DART SERVICE INSTRUCTION

TO AMEND INSTALLATION INSTRUCTIONS IIN-D412-742 REV. E
AND INSTRUCTIONS FOR CONTINUED AIRWORTHINESS ICA-D412-742 REV. 4

REF. FAA STC: SR01583SE
REF. CANADIAN STC: SH05-37
REF. EASA STC: EASA.IM.R.S.01126

The purpose of this service instruction is to provide instructions for upgrading D412-742-011/-013 Skidtube Installations at CHG 006 and earlier with the heavy duty wearplates of CHG 007 and subsequent installations. The DSI9517-011 Wearplate Kit contains the necessary wearplates and hardware for this upgrade.

**FIGURE 1: CHANGE AT FORWARD SADDLE LOCATION
WITH DSI-9517-011 KIT INSTALLED**

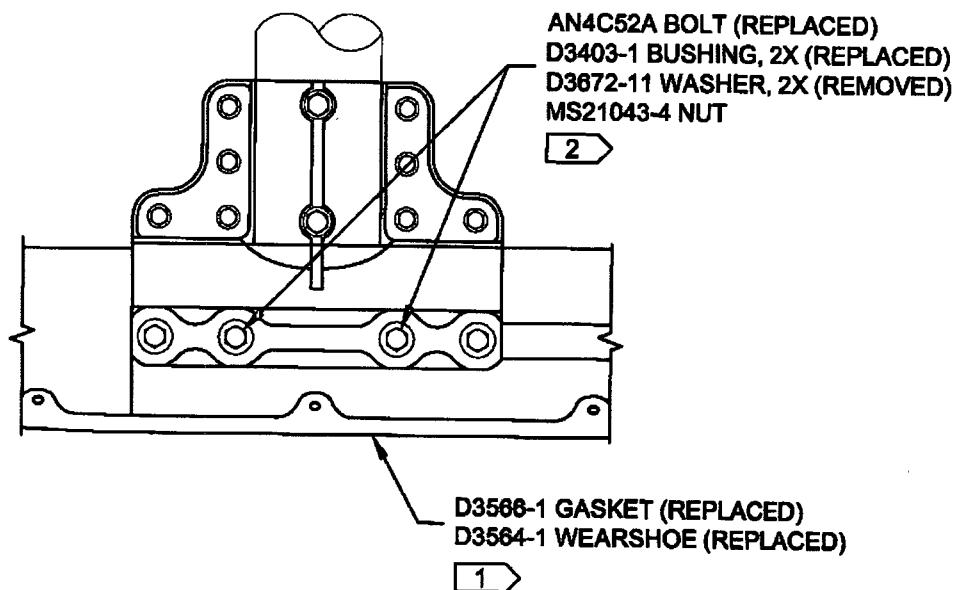
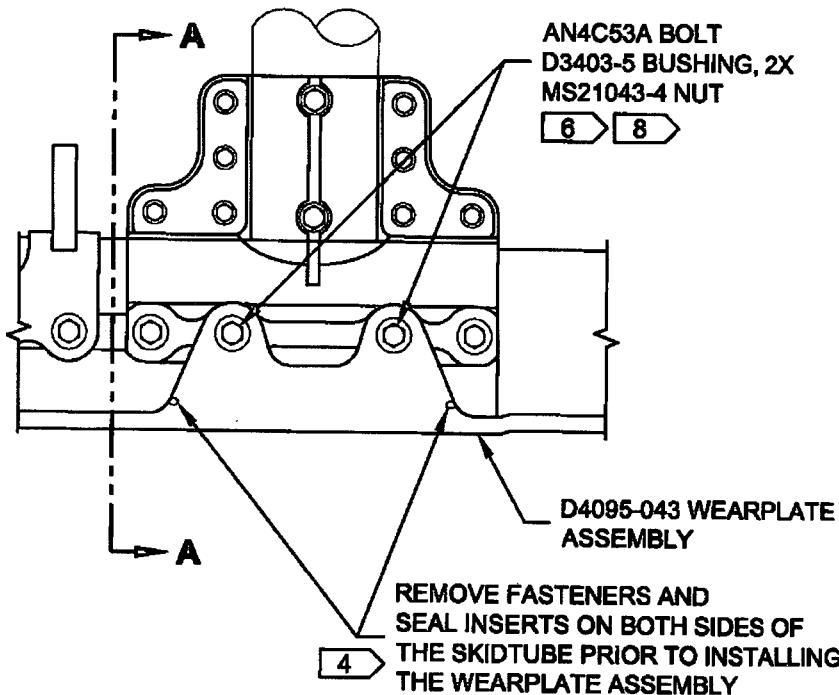
1. Remove existing D3564-1/-3/-5/-13 Wearshoes and D3566-1/-3/-5/-13 Gaskets per Item 32.6.1 of ICA-D412-742.
2. Remove qty(4) AN4C52A Bolts, D3403-1 Bushings, and qty(8) D3672-11 Washers as indicated in Figures 1 and 2 of this service instruction.

3. Inspect the skidtube and saddles per Chapter 5 of ICA-D412-742.
4. Seal existing inserts located on both sides of the skidtube in area shown in Figures 1, 2 and 3 of this service instruction using Sikaflex -241/-291 or Proseal 890 or MIL-S-8802 Class 2B sealant.

5. Locate the D4095-041/-043 Wearplates as shown in Figure 1, 2 and 3 of this service instruction.
6. Transfer drill qty (2) Ø0.438 hole from the skidtube/saddle to the D4095-041/-043 Wearplate Assemblies. Deburr. Touch up finish per Item 5.2.14 of ICA-D412-742 as required.

8. Install D3403-5 Bushings and AN4C53A Bolts in lieu of D3403-1 Bushings and AN4C52A Bolts removed at step 2 above. Ensure that the nuts on the AN4C Bolts are on the inboard side of the skidtube. Torque to 50-70 in-lbs (5.7-7.9 N-m). Note: It is acceptable to trim the smaller end of D3403-5 Bushings to obtain a 0.005" pinch fit on the Wearshoes/Saddles
